FR02	Flood Risk	<p>An area of the proposed development on the northern side is predicted to be extensively flooded in shallow depth possibly due to inadequate provision of overland flow path. Please check.</p> 	Post Development flood risk	<p>We noticed an added flood flow diversion channel on the upstream side of Grand Drive. This has alleviated flooding at this location.</p>
FR 03	Flood Risk	<p>A normal depth water level boundary is adopted in the HEC-RAS model with a hydraulic gradient of 0.02 or 2% assumed for the receiving estuary channel. A constant tidal level boundary which takes into account of Sea Level Rise (SLR) and Vertical Land Movement (VLM) is considered more appropriate. The SLR scenario should be as per the Coastal Hazards and Climate Change Guideline (July 2024, MfE) for upto year 2130.</p>	Tidal level can have a impact on flood levels.	<p>Tidal boundary has been added at 3.54 mRL -okay</p>

FURTHER REVIEW COMMENTS (after review of latest submitted documents and model files)

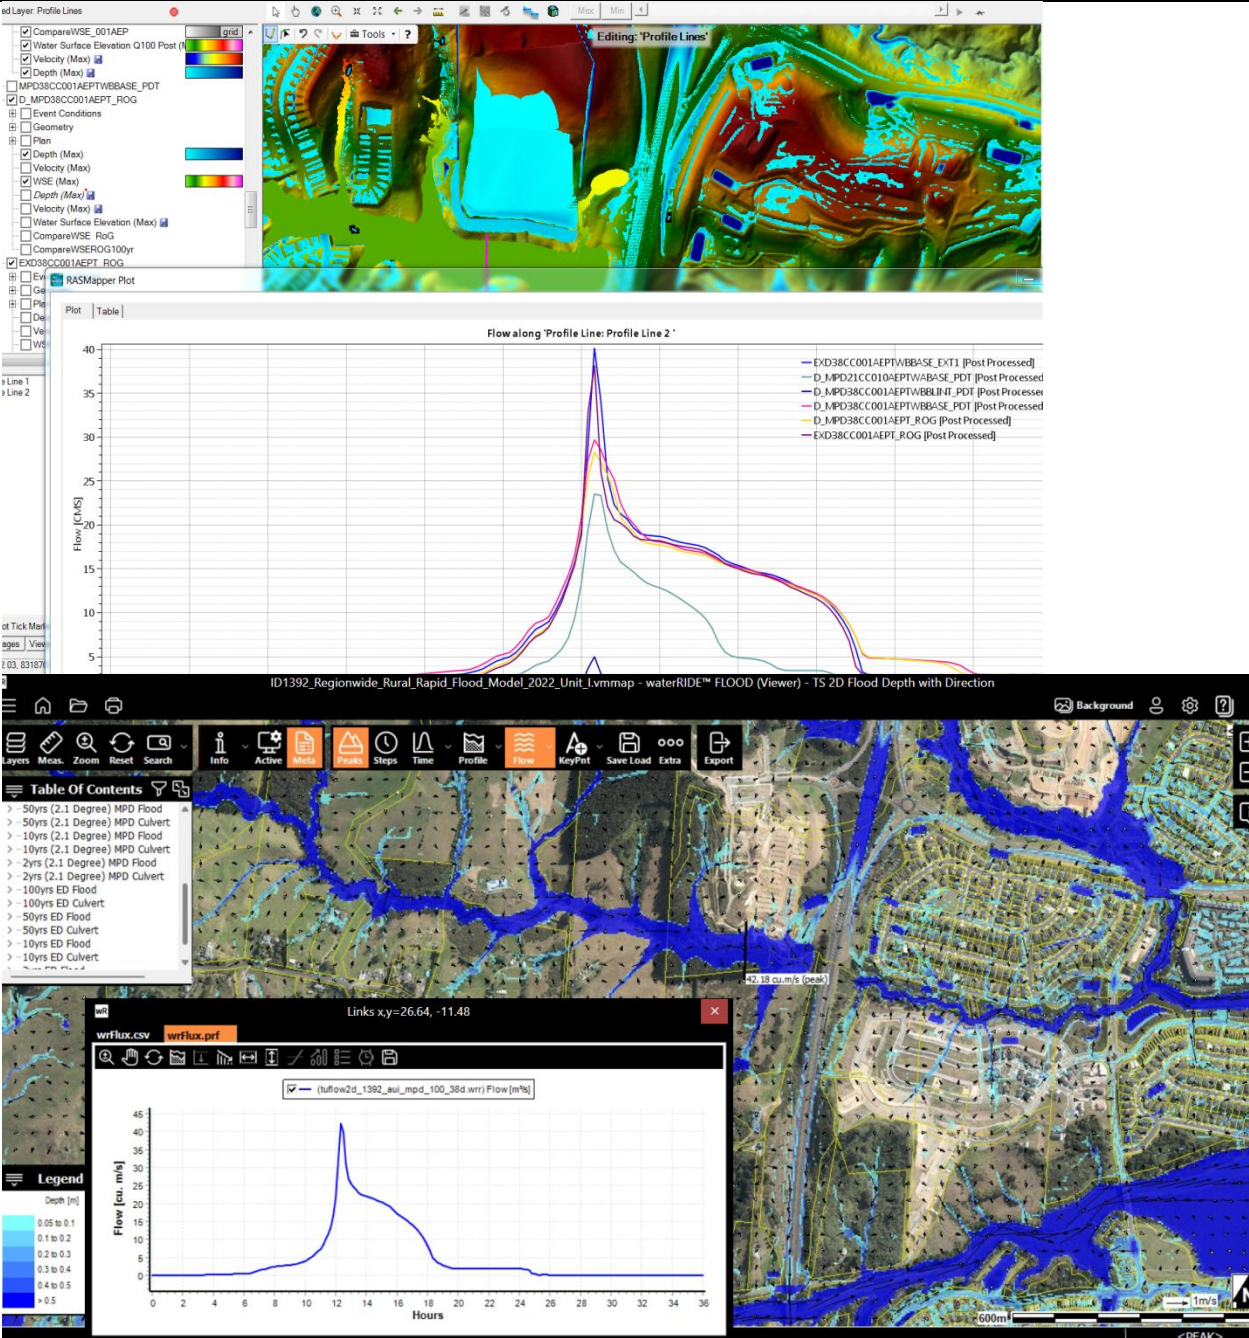
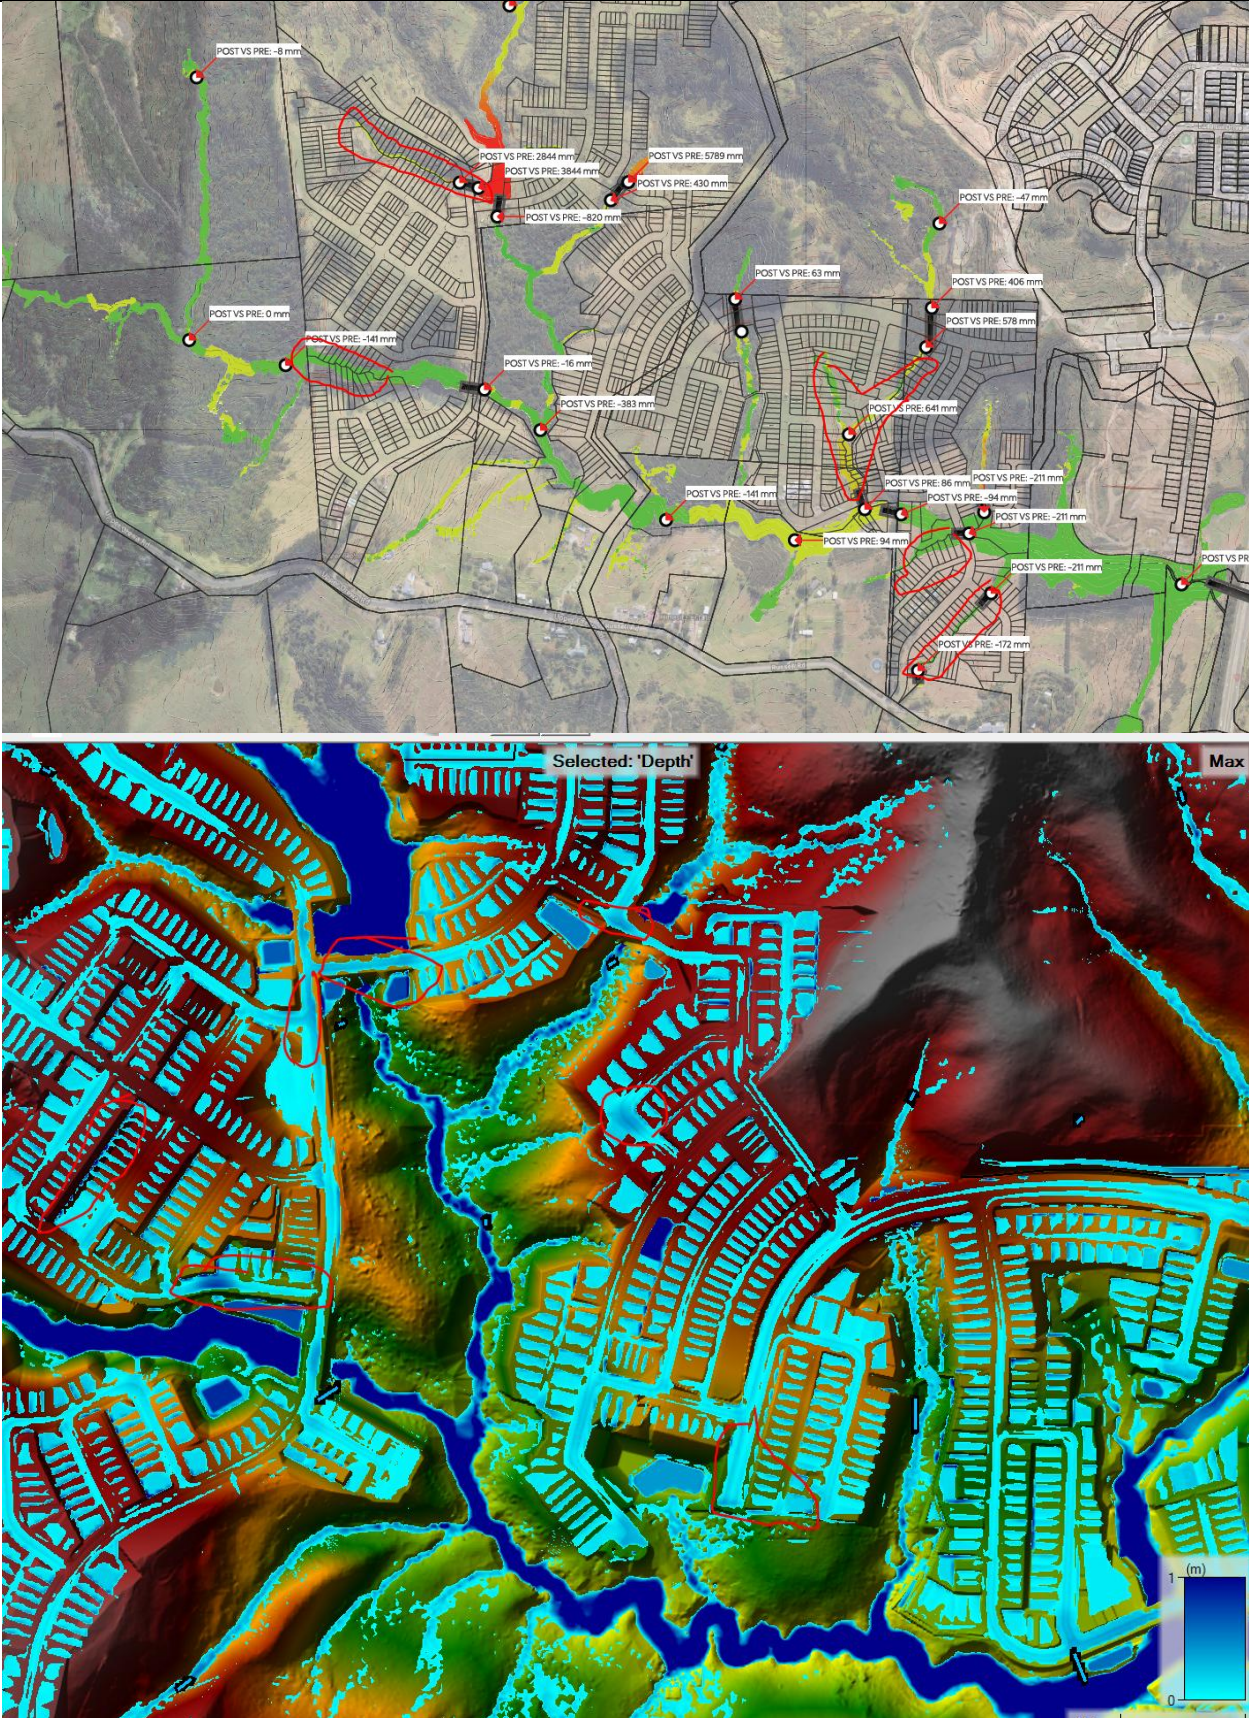
<p>The screenshot displays the waterRIDE software interface. The top panel shows a 3D visualization of a flood event with a color-coded depth map. Below this, a graph titled 'Flow along Profile Line: Profile Line 2' shows flow rate (m³/s) over time (hours) for various scenarios. The bottom panel shows a 2D map of the flood extent with a legend for depth (m) ranging from 0.05 to 0.5. An inset window shows a detailed flow profile graph for a specific link, with a peak flow of 42.18 m³/s.</p>		
FR11	Flood Risk at Post Development properties and Roads	<p>The ROG model simulations indicates excessive depth of flood water at roads along overland flow paths or low points and on private lots with overland flow paths or ponding. We are aware of the fact that drainage pipes are not included in this model which may reduce the flood extent. However, as per SWCOP, small pipes (<600mm in Dia) should be ignored when assessing flood risk at properties. Therefore, the flood risk needs to be managed by:</p> <ul style="list-style-type: none">- require specific design of minimum floor levels on private lots with flood depth >0.1m, or with overland flow path traversing through.- easement required to protect the route of overland flow paths - no obstructions.- refined terrain and road design to minimise flood risk and ponding depths.	To protect future buildings and residents from flood risk

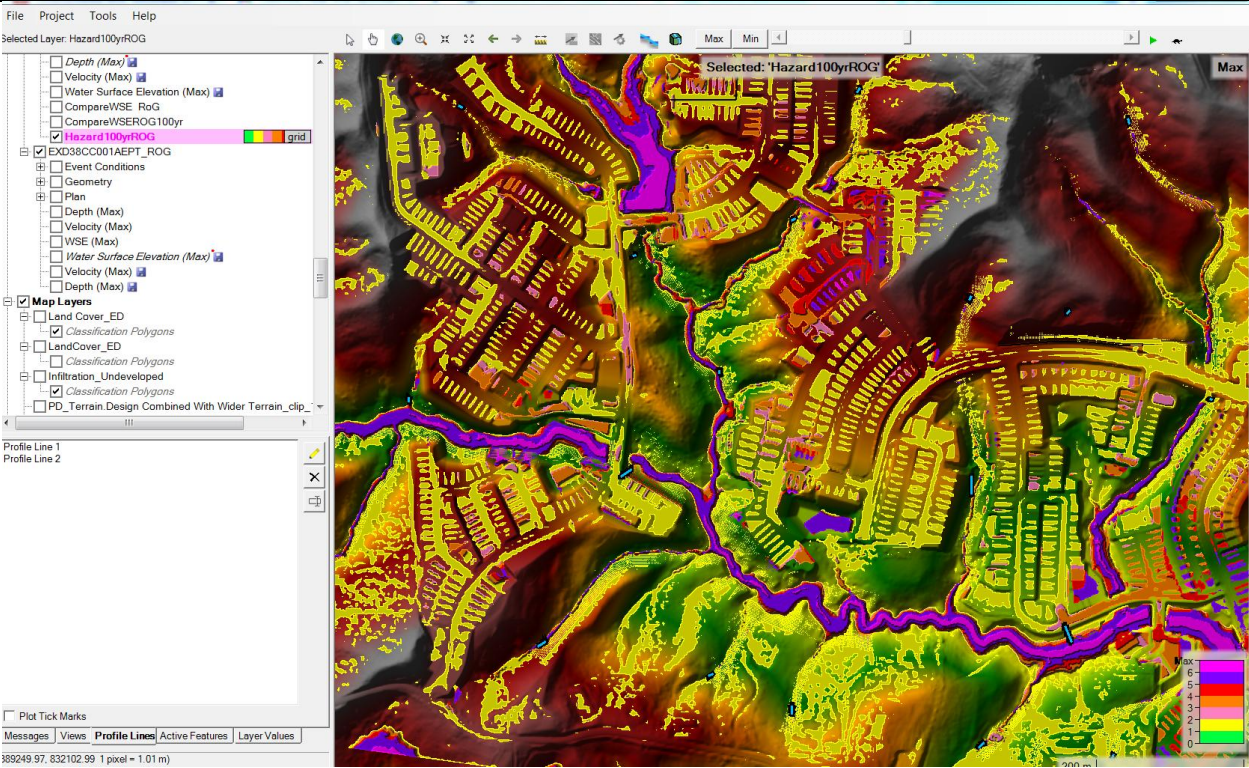
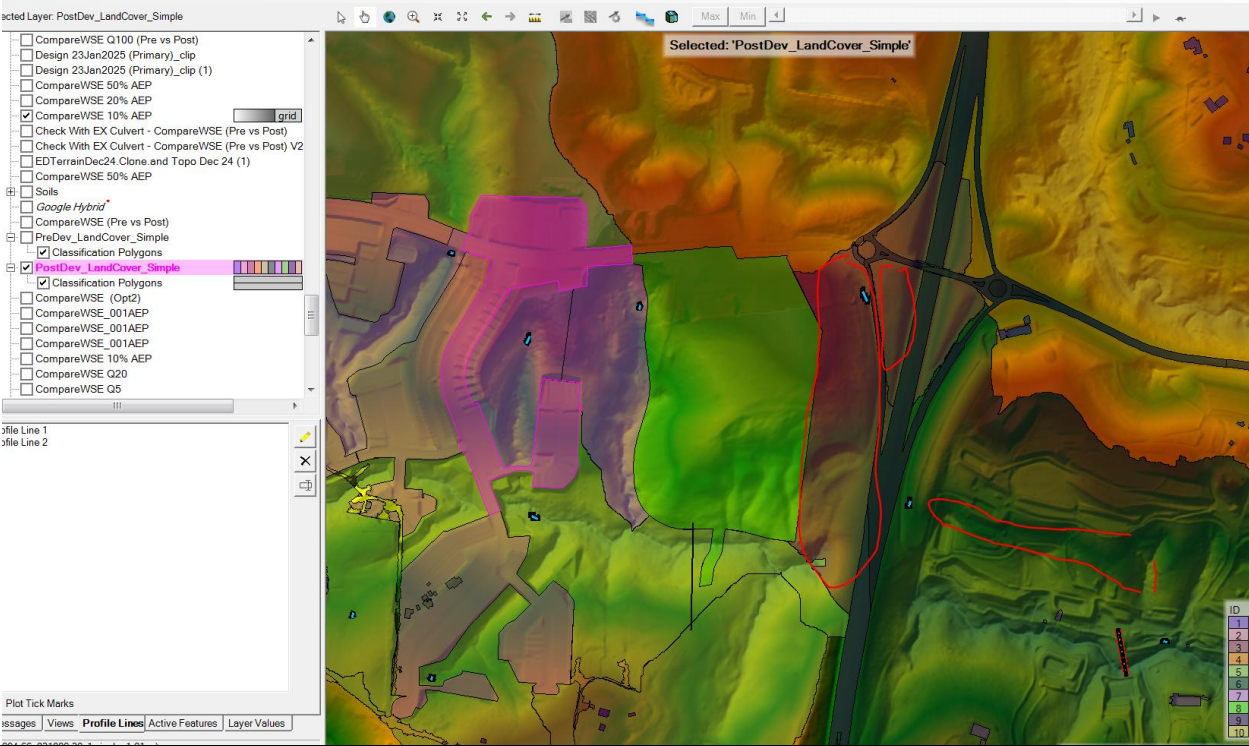
FR12	Flood Hazard Assessment	<p>A flood hazard assessment adopting the ADR flood hazard guideline classifications should be undertaken and managed appropriately.</p> <p>Below is a map showing flood hazard classifications for the ROG 100yr 3-8 MPD scenario using the ADR guideline. There are a few areas shown with hazard class above H2 - unsafe for vehicle. Please investigate and manage accordingly.</p>	Protect future residents from flood hazards
